Access Compliance Report

Public Rights-of-Way

(Curb Ramps)

Intersection ID: 7593	Main Street: BANNISTER_PL	Cross Street: YUMA_ST	Location: NW
ADA ID: F5EF1BE2759B	Ramp Type: Perp	Initial Pass/Fail: Fail	Overall Compliance: No
Severity Score: 22.5			
Codes/Mitigation Info/Possible Solution		Field Measurements/Component Compliance

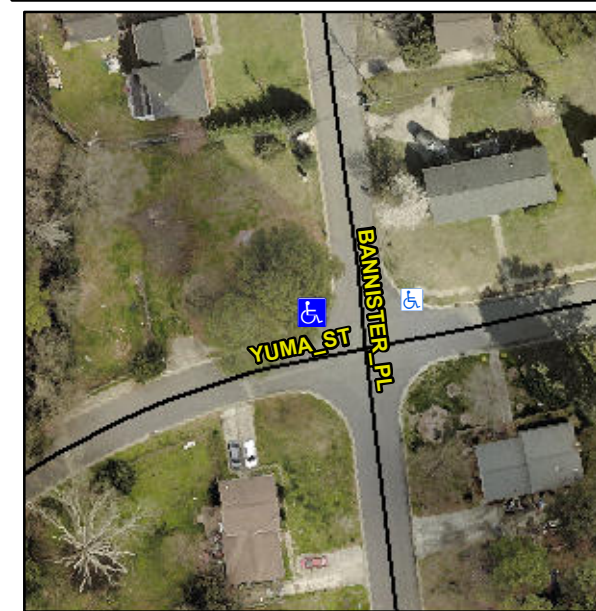
Not Found, R304.5.1, R304.2.2, R304.5.3

Compliance	Description	Data	Compliance	Description	Data
N/A	Ramp Length (in)	24.0	No	Ramp Slope (%)	8.8
No	Ramp Width (in)	42.0	No	Ramp XSlope (%)	3.6
N/A	Flare Type LT	N/A	N/A	Flare Type RT	N/A
N/A	Flare Slope LT (%)	N/A	N/A	Flare Slope RT (%)	N/A
N/A	Flare Traversable LT?	N/A	N/A	Flare Traversable RT?	N/A
N/A	Landing Length (in)	N/A	N/A	DWS Provided?	N/A
N/A	Landing Width (in)	N/A	N/A	DWS Contrast?	N/A
N/A	Landing Slope (%)	N/A	N/A	DWS Length (in)	N/A
N/A	Landing X Slope (%)	N/A	N/A	DWS Full Width?	N/A
N/A	Landing Curb? (Y/N)	N/A	N/A	DWS Offset (in)	N/A
N/A	Shared Landing?	N/A			
N/A	Gutter Ponding?	N/A	N/A	Gutter Slope (%)	N/A
N/A	Gutter Lip Ht (in)	0.75	N/A	Gutter X Slope (%)	N/A
N/A	Painted X Walk1?	No	N/A	Painted X Walk2?	N/A
	X Walk 1 Direction	To E		X Walk 2 Direction	N/A
N/A	X Walk 1 Width (in)	N/A	N/A	X Walk 2 Width (in)	N/A
	X Walk 1 Slope (%)	8.0		X Walk 2 Slope (%)	N/A
	X Walk 1 X Slope (%)	0.6		X Walk 2 X Slope (%)	N/A

Remove & Replace Entire Ramp.
